**Project: Hurricane Laura Stom Repairs - Rosteet Annex**

**Addendum No. 2**

**Addendum Number 2**  
December 7, 2023

**Calcasieu Parish School Board**  
Rosteet Annex  
Engineer's Project Number: 23023

SHEET NUMBER  
**A-2.3**  
1ST FLOOR PLAN

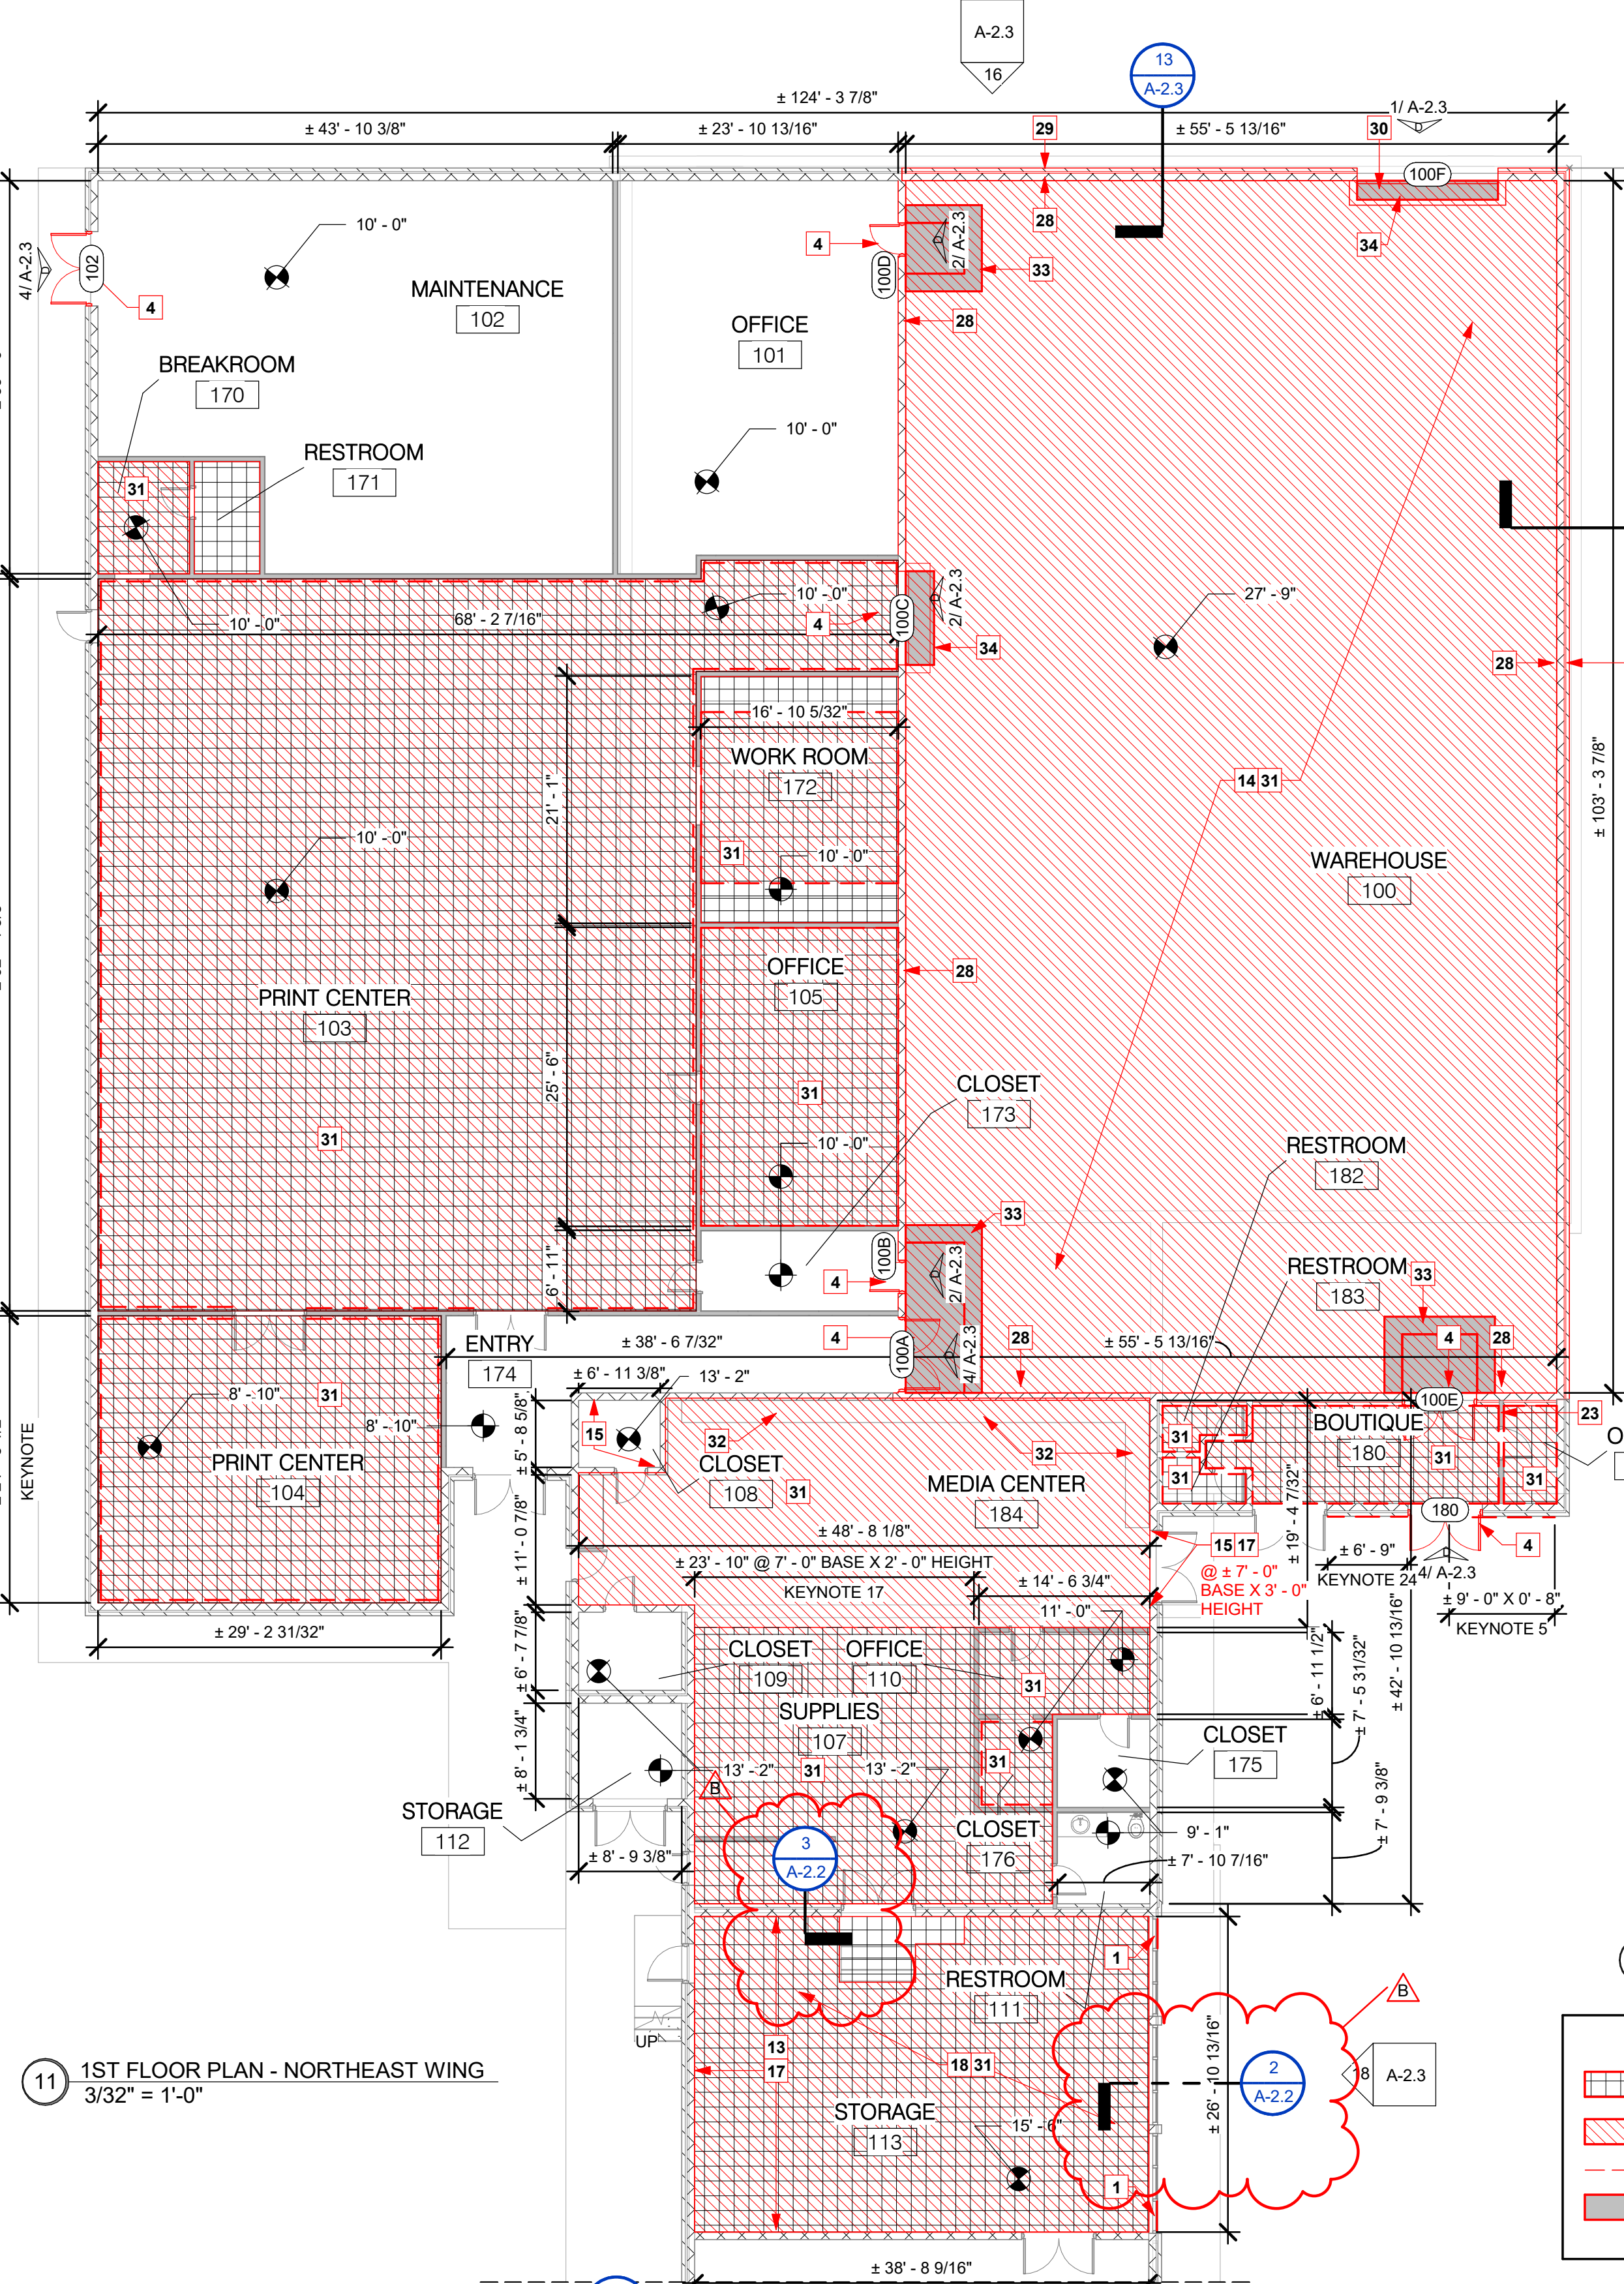
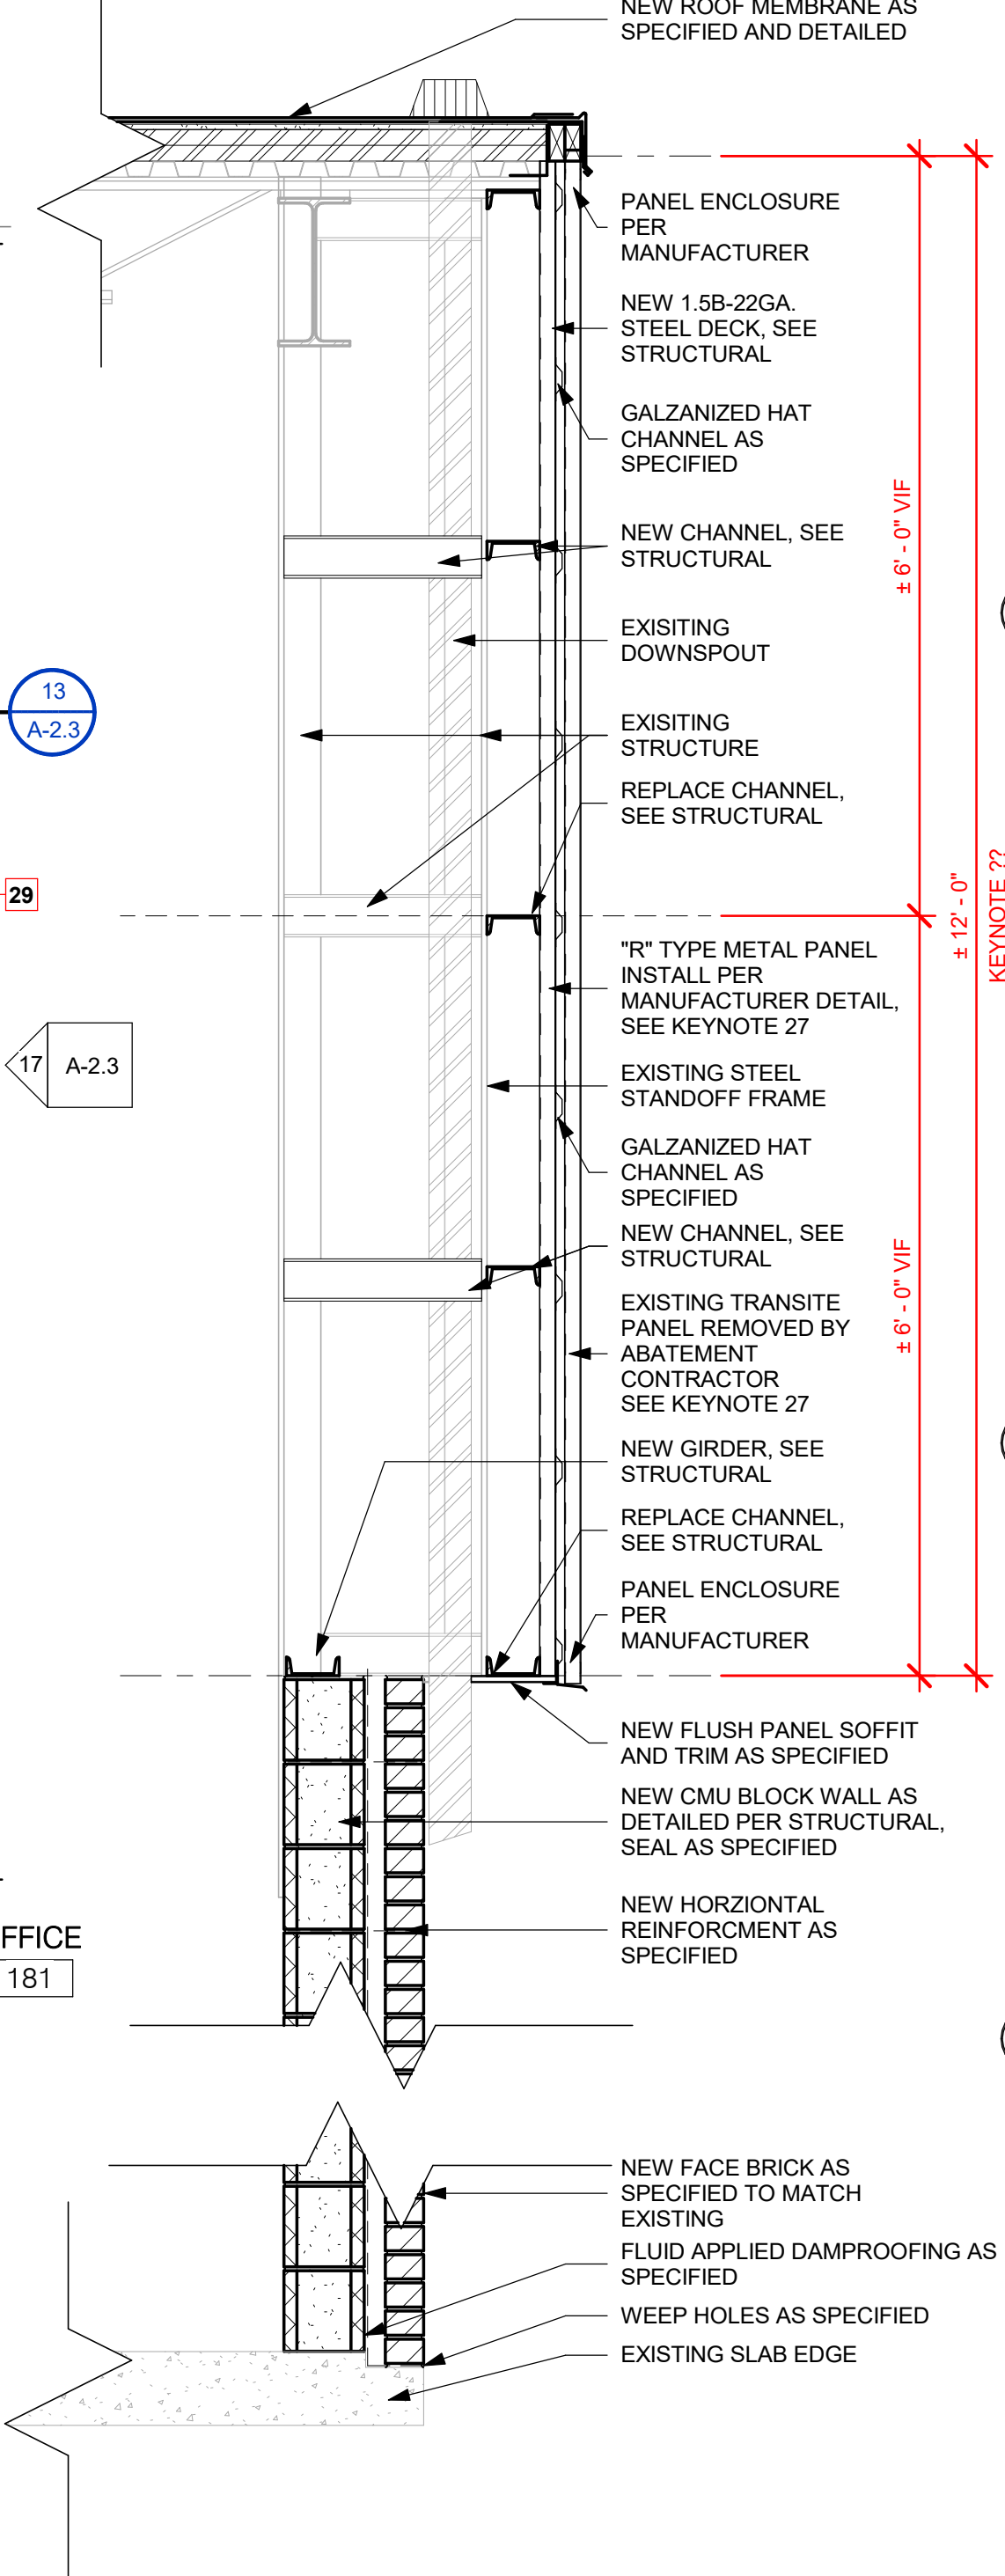
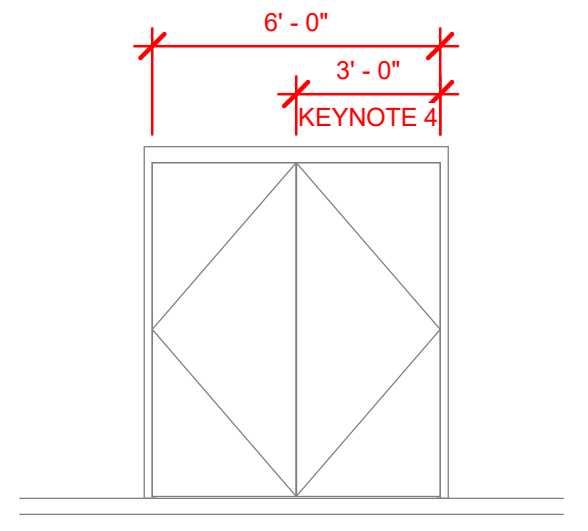
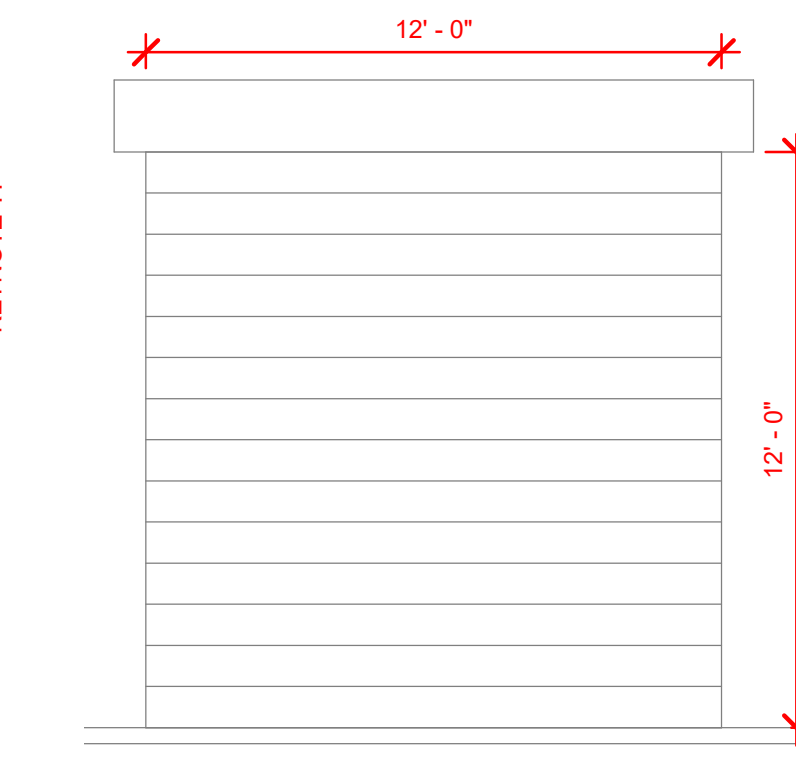
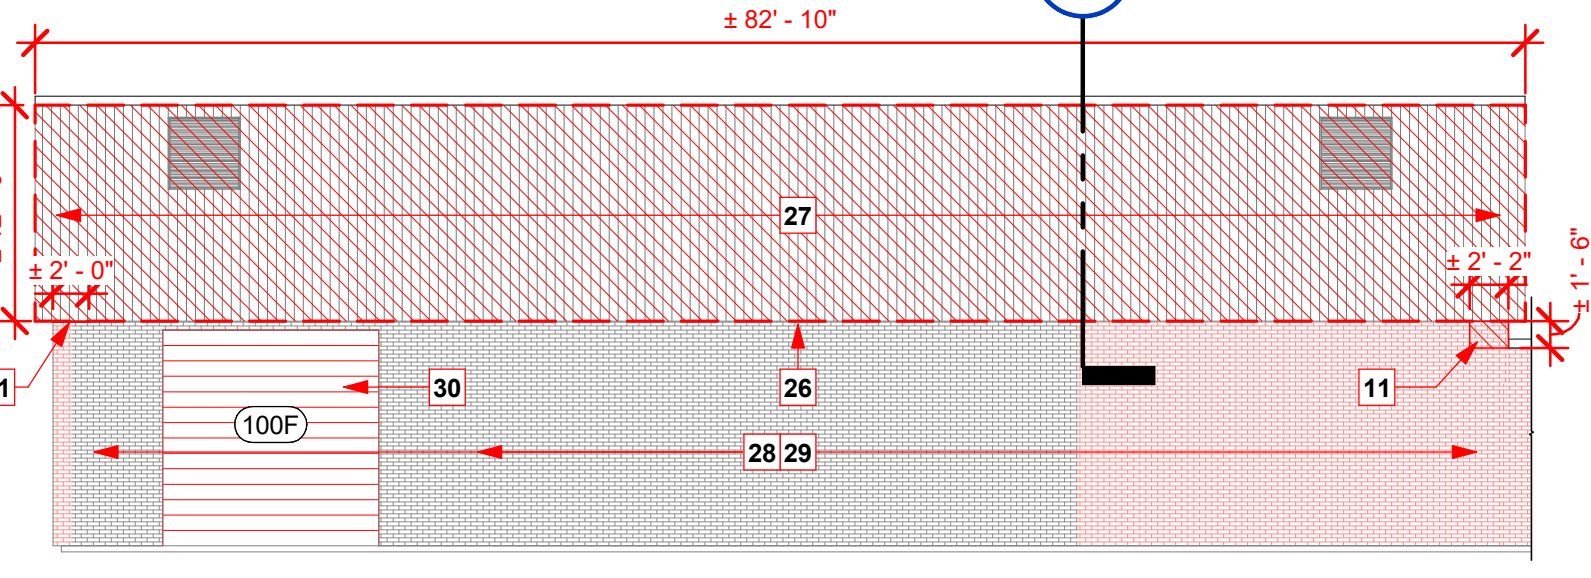
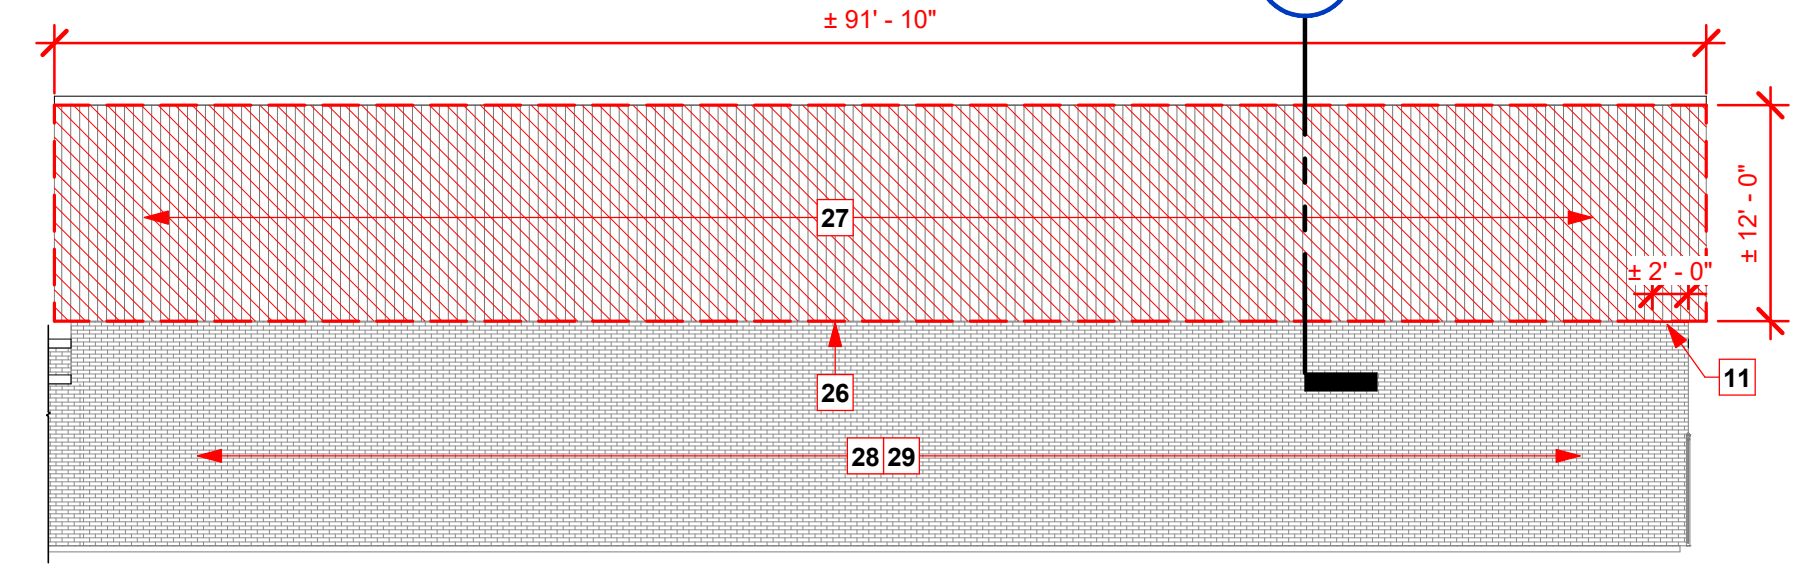
Item No. 4 - See attached revised sheets A-2.2 & A-2.3.
